# UNITED STATES PATENT AND TRADEMARK OFFICE

APPLICATION NO.	FILING DATE	FIRST NAMED INVENTOR	ATTORNEY DOCKET NO.	CONFIRMATION NO.
10/761,699	01/21/2004	Thomas M. Conway	6570/91346	3354

### **DETAILED ACTION**

Thomas M. Conway  
ADJUSTABLE SAFETY NET SYSTEM  
Serial No. 10/761,699  
Replacement Sheet

FIG. 1

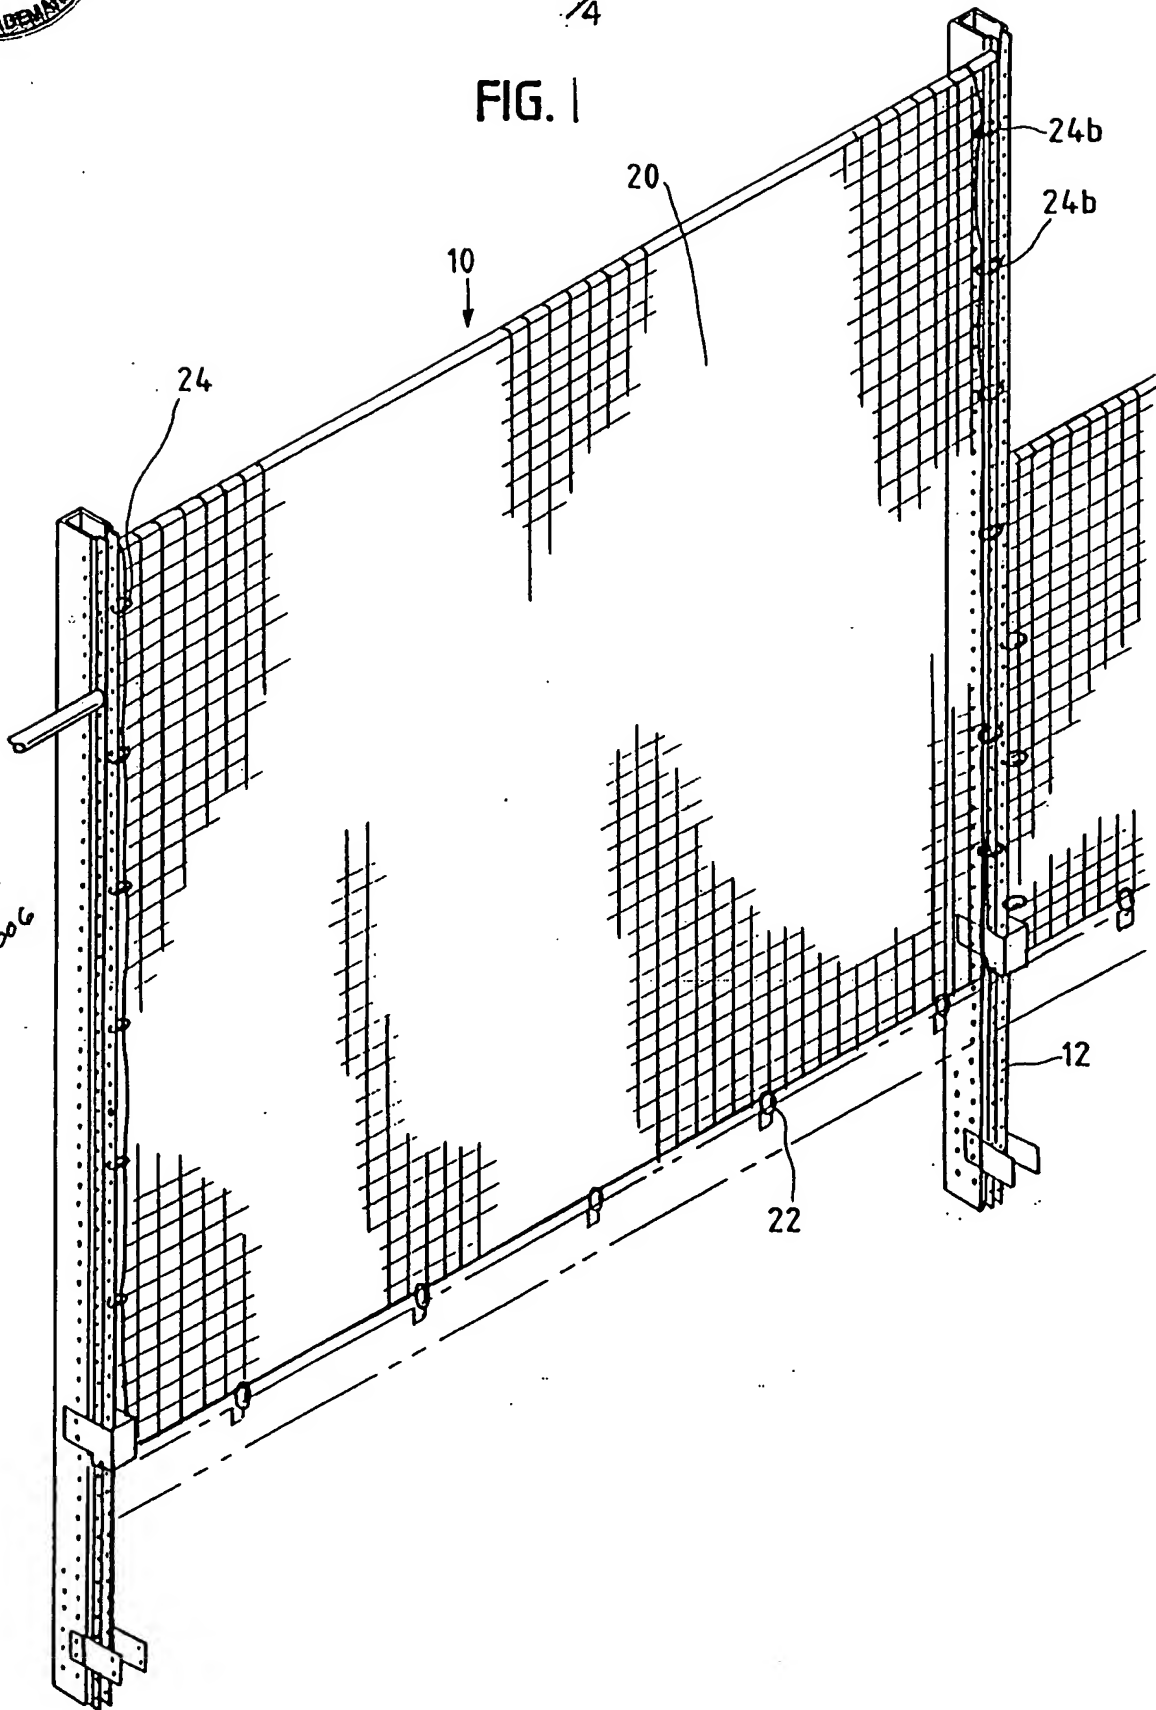
OK to enter.  
ZWN 07/13/2006
